EEE & LPI comments

4/16/2019

Mechanism To Prevent Partial Refresh

lpi_tx_mode

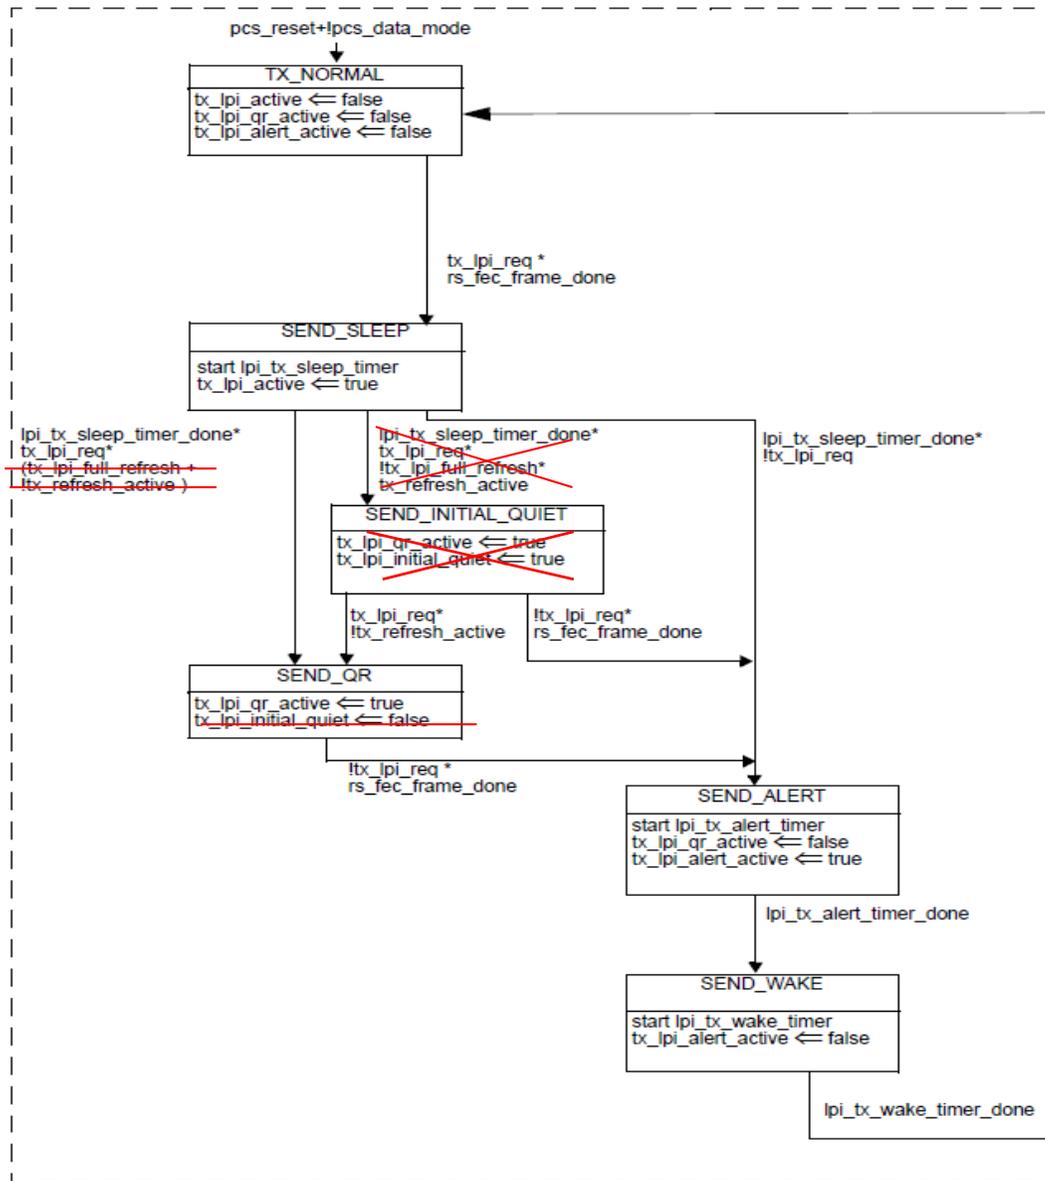
- Section 149.3.6.2.2 take out definition of tx_lpi_full_refresh
- Section 149.3.6.2.2 take out definition of tx_lpi_initial_quiet
- Section 149.3.6.2.2 take out tx_lpi_initial_quiet usage in lpi_tx_mode

The variable is set to QUIET when (tx_lpi_qr_active * (!tx_refresh_active + ~~tx_lpi_initial_quiet~~)).

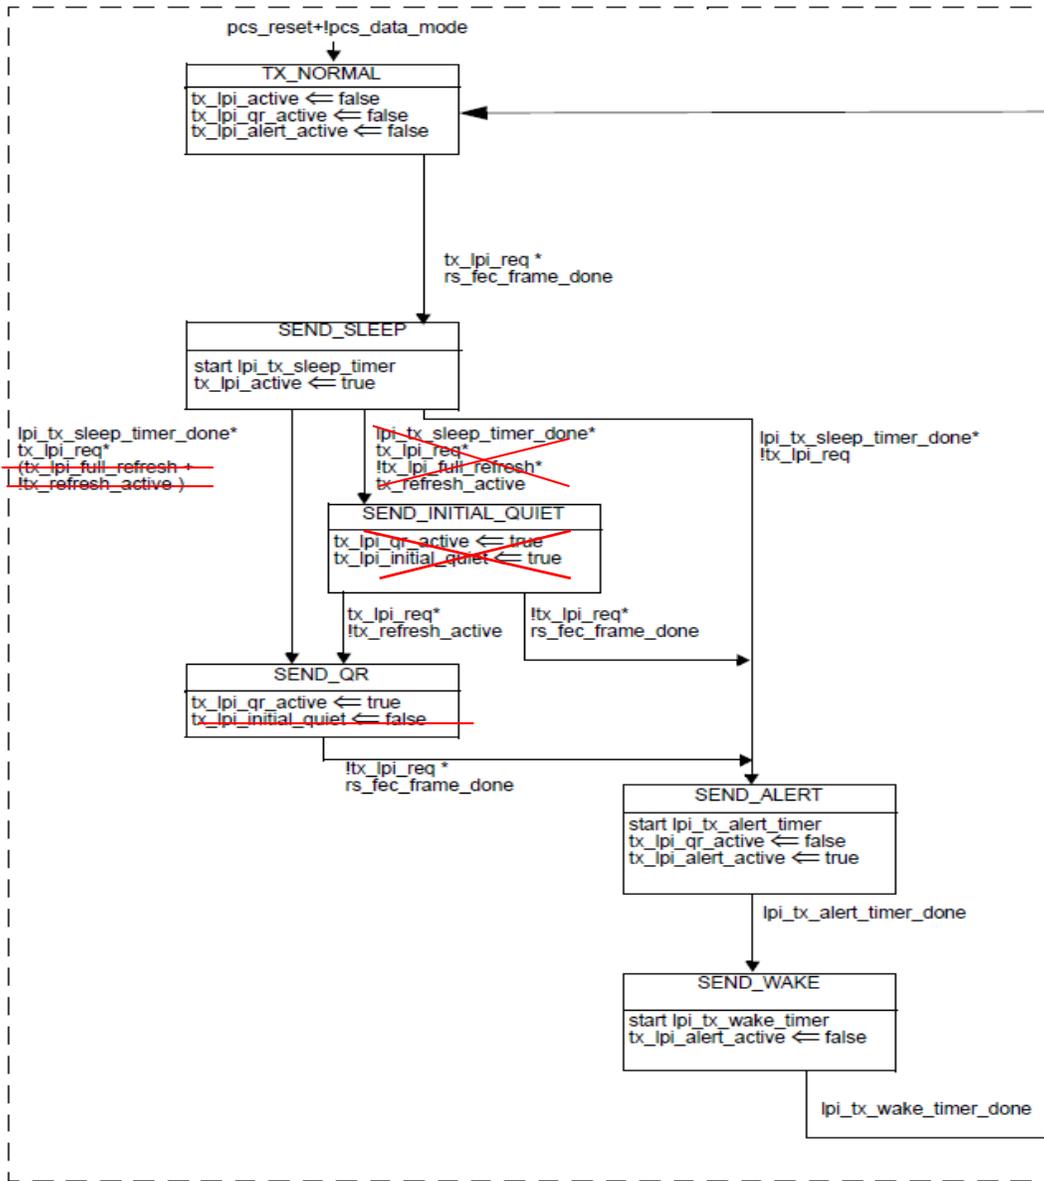
Mechanism to Prevent Partial Refresh

- Blue lines are from Benjamin_3ch_03_041619

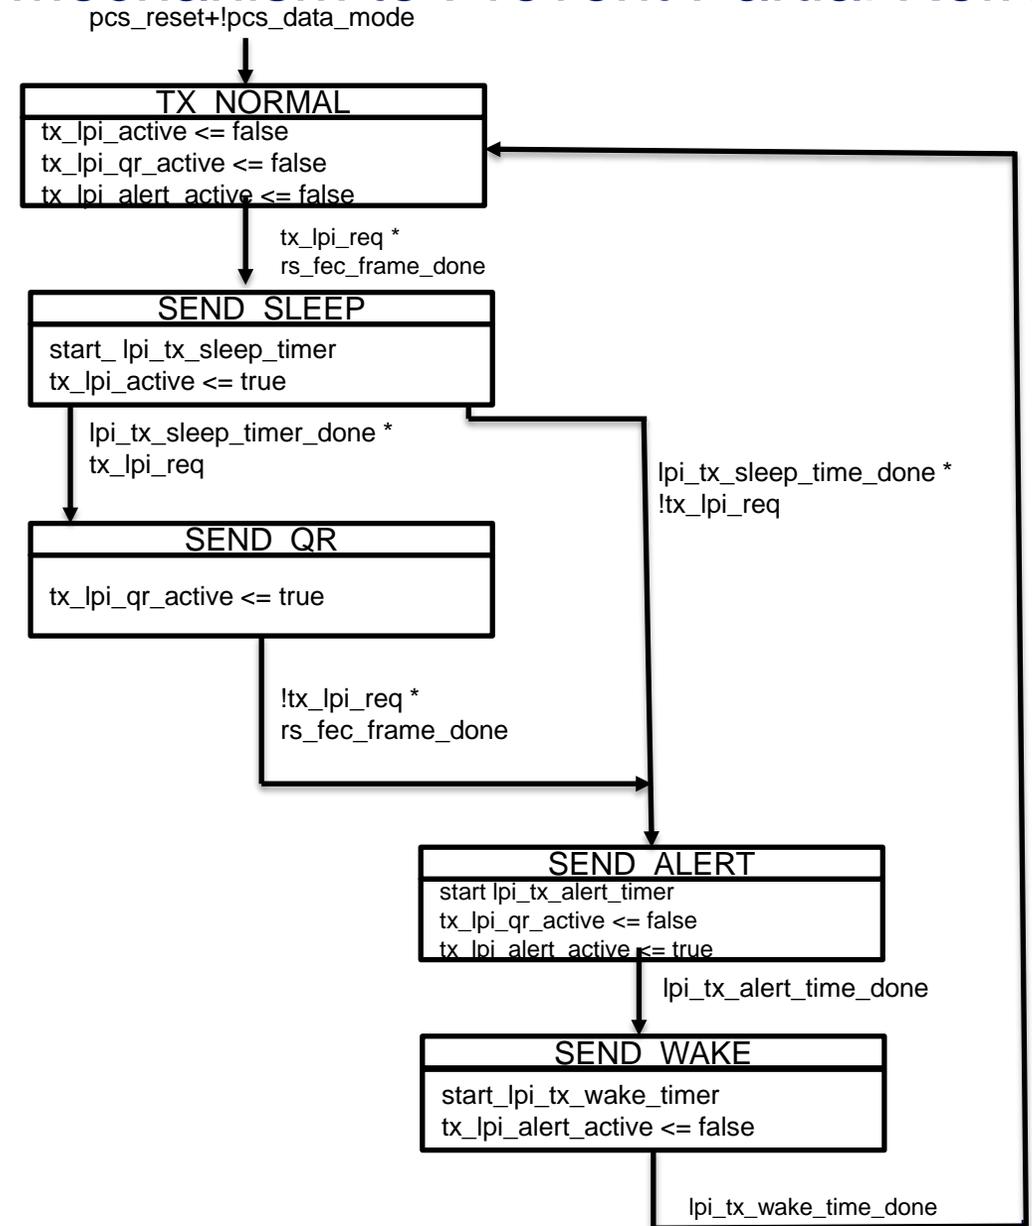
Mechanism to Prevent Partial Refresh
